**Descriptive Report to Accompany
Hydrographic Survey H11614
Scale 1:20,000, Surveyed 2007
M/V Thomas R. Dowell and F/V Lacey Marie
Science Applications International Corporation (SAIC)
Paul L. Donaldson, Lead Hydrographer**

PROJECT**Project Number:** S-J977-KR-SAIC**Dates of Instructions:** October 18, 2006**Task Order#:** T0002**Dates of Supplemental Instructions:** 25 October 2006, 16 November 2006, 09 January 2007, 30 May 2007, and 03 October 2007**Sheet Letter:** C**Registry Number:** H11614**Purpose:** To provide NOAA with accurate hydrographic survey data suitable for item detection and debris mapping in the assigned area: Sheet C (H11614) in Lake Borgne, Louisiana.**A. AREA SURVEYED**

Feature #: 0017 Least Depth: 4(ft), 1.28(m) Lat: 29 55 25.95N Lon: 089 43 41.69W Ping: Beam:

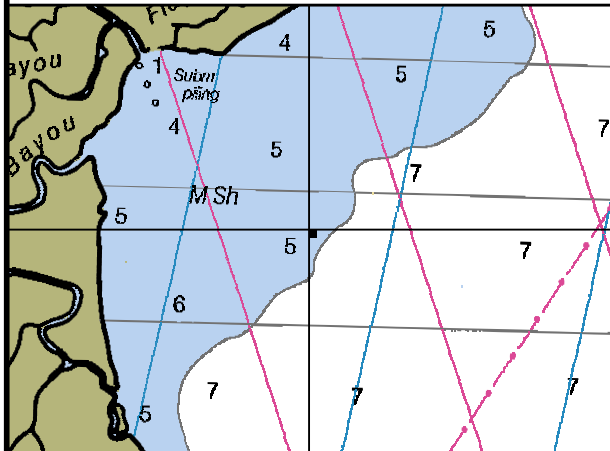
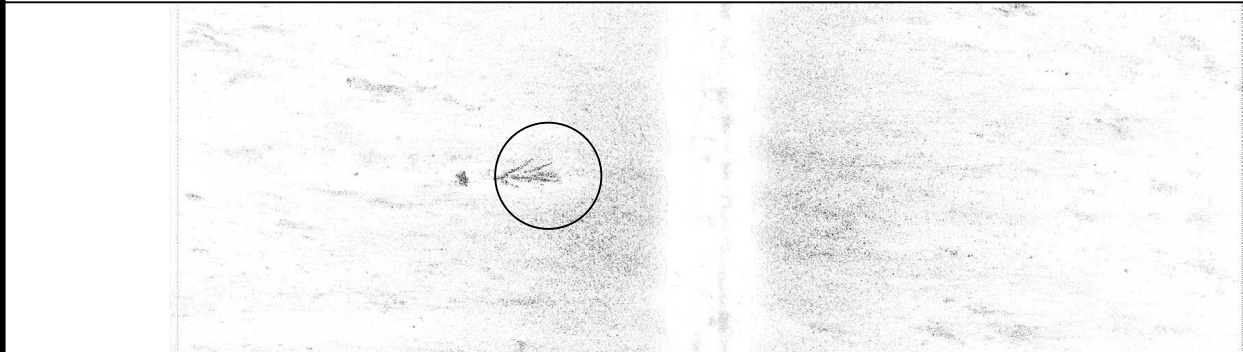
COMMENT:
SNAG SUBMERGED Plot sounding
and label Subm Snag (least
depth estimated from side
scan).

Feature #: 0024 Least Depth: 7(ft), 2.16(m) Lat: 29 52 04.50N Lon: 089 40 16.37W Ping: Beam:

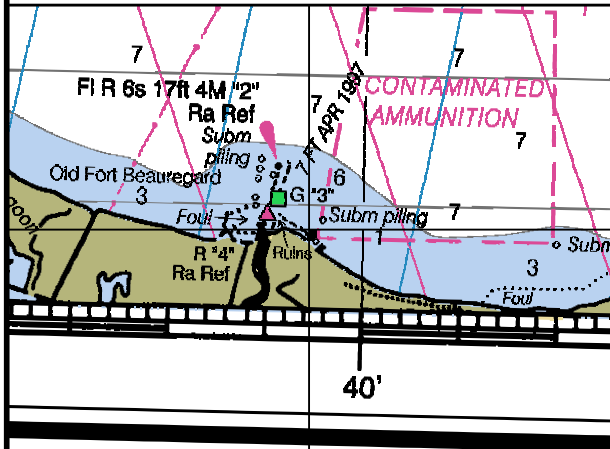
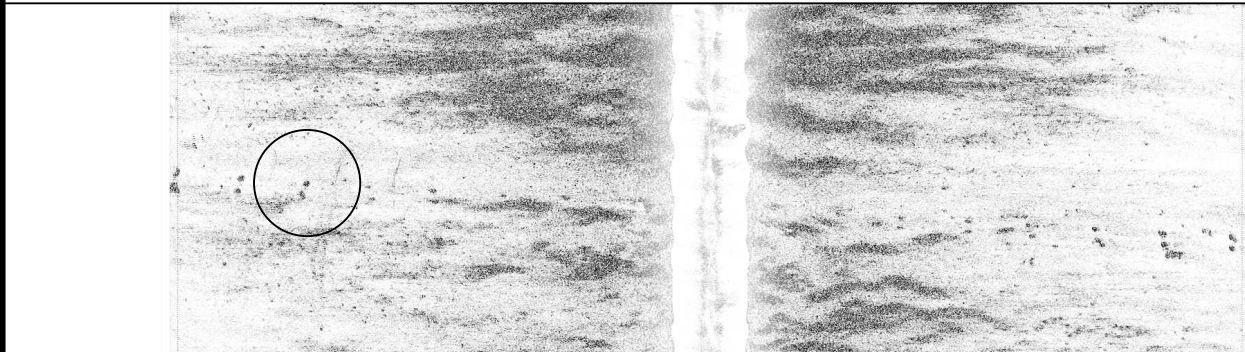
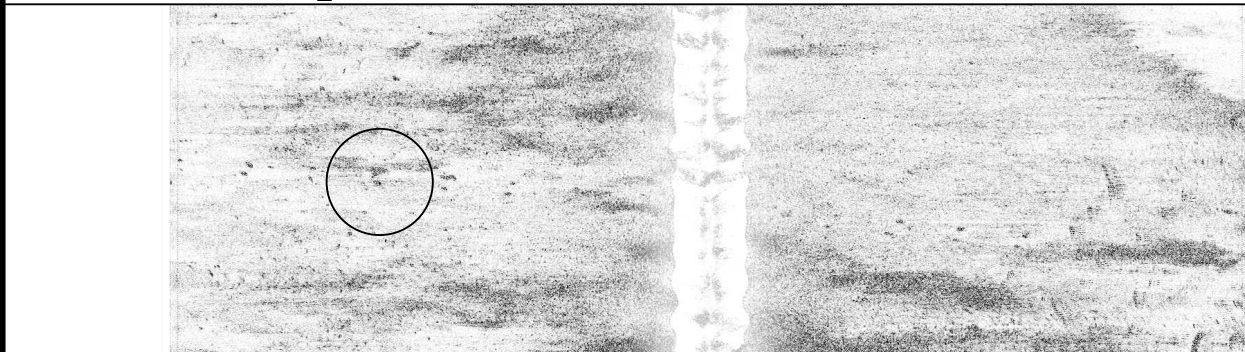
COMMENT:
SUBM PILE No Plot. See Features 10, 11 and 23 (least depth estimated from side scan).
